## Cable Clamp Optimization for K-Series

**Fig. 1** K-Series' cable clamp mounting position

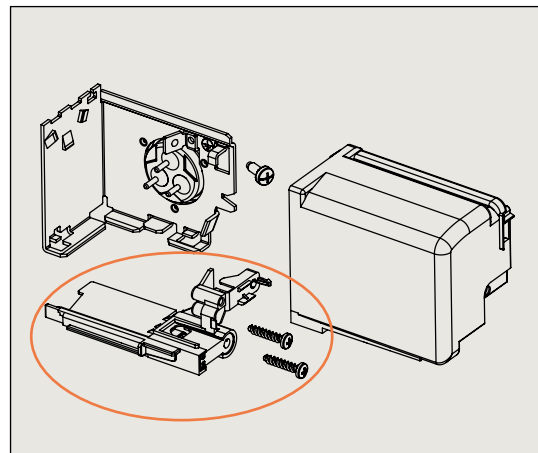
Currently, Secop uses two types of cable clamps for the K-Series. The older models (also known as KAPPA) use a white cable clamp (code number 11341000, see Figure 2), which meets the V2 safety class standard.

In contrast, the new KL-Series, launched in 2023, uses a black cable clamp (code number 16058100, see Figure 3), which complies with the higher V0 safety class. Both versions share the same design and dimensions.

To standardize the accessory components of the K-Series and optimize the supply chain, Secop has decided to unify the cable clamp across all K-Series models by using the black cable clamp currently employed in the KL-Series.

Starting in September 2025, Secop will standardize the cable clamp in all K-Series deliveries to code number 16058100.
